Appendix F

Town/Township/Council Correspondence

RE: County Road 17 Hawkesbury Bridge Replacements

GWP 4203-15-00

Figure 1: Channelized Right Turn with Acceleration Lane ("Option A")

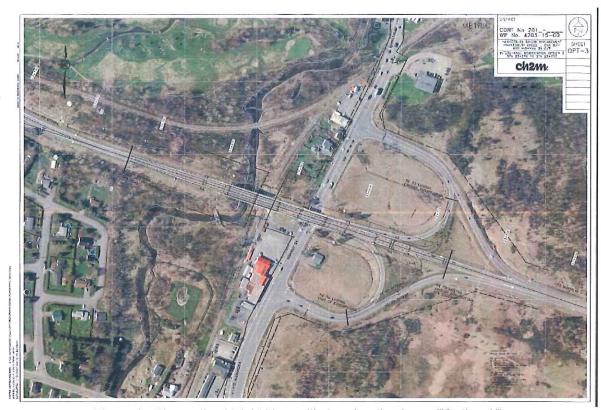
A detailed geometric review of Option B was completed which determined that a 30 m ramp radius at that skew angle is not desirable. For interchange ramps, the minimum radius for an inner loop is 45m per Section F.5.2 of the Geometric Design Standards for Ontario Highways (GDSOH).

For channelized right turns at an intersection, Option A, the minimum radius can be 25 m per Section E.8.4 of the GDSOH, but the skew angle makes this very tight for trucks and may surprise drivers with such a tight curve. Also, this option still did not provide the recommended acceleration lane length to provide free flow movements.

For these reasons, both these alternatives were abandoned.

Figure 4: Channelized Right Turn with Sub-Standard Acceleration Lane and Merge Signs

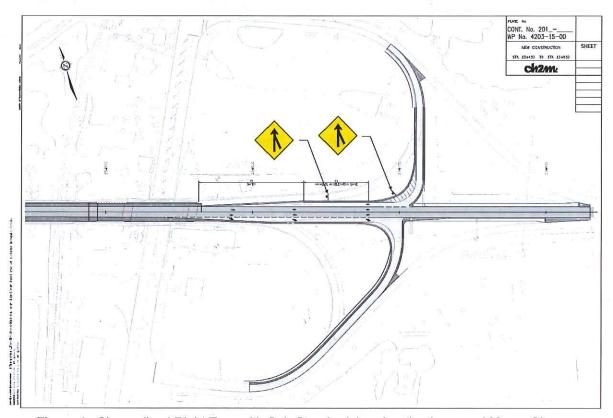
Jacobs looked at another version of a channelized right turn and an acceleration lane after the April 15, 2019 meeting. This option does not meet the minimum required acceleration lane length for free flow conditions (per GDSOH Section E.8.4) without widening the bridge. However, <u>sub-standard</u> acceleration lane lengths may be permitted, so long as they are controlled by signage (merge signs or yield signs per Ontario Traffic Manual (OTM) Book 5 and 6). This is shown in Figure 4 below. This is a feasible option, however, due to the sub-standard acceleration lane, vehicles and trucks will not have adequate space to get up to speed prior to the merge. Please note that Figure 4 will be the channelized right turn version that will be presented to the public, not Option A.

Figure 5: T-intersection with Stop Condition (Preferred Alternative)

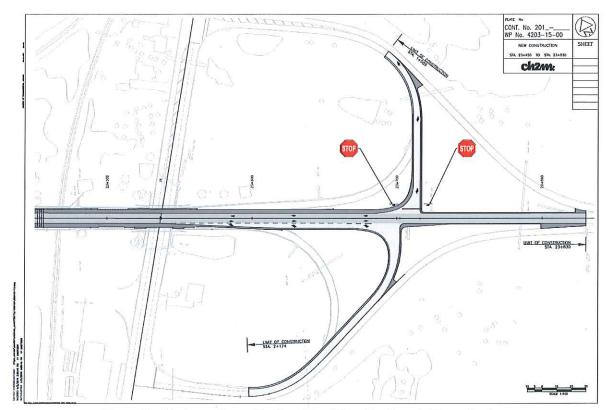
The current proposed design is a T-intersection with a stop condition, shown in Figure 5. Traffic operates at acceptable levels of service, trucks can navigate the movement without crossing the centre line and there are adequate sight lines with this option. This is still the preferred alternative.

The Ministry of Transportation (MTO) has reviewed the independent third-party report produced by GHD submitted on November 21, 2019. Upon review of the report and conclusions, the MTO will proceed with the current preferred alternative of a stop condition on the N/S-W (Highway 34 South to County Road 17 West) ramp.

Currently, County Road 17 in this location has a design speed of 90km/hr and is posted at 90km/hr. The proposed MTO design will keep the same design speed, with a reduced posted speed of 70km/hr. Due to the geometry of the future narrower bridges and proximity to the interchange, a channelized right-turn at a design speed of 90km/hr can not be accommodated within design standards. Therefore, a stop condition at the N/S-W ramp terminal on County Road 17 has been chosen as the preferred alternative.

The report produced by GHD suggests that a design speed of 60km/hr on County Road 17 would accommodate a channelized right-turn at this ramp terminal. Without implementation of significant urbanization infrastructure, geometry changes, and traffic calming devices, the MTO feels a design speed of 60km/hr is not feasible along County Road 17 in this location.

The MTO will not design and construct this intersection to a design speed chosen to satisfy a favoured alternative, as this could lead to operational issues in the future, with few options left to mitigate them.
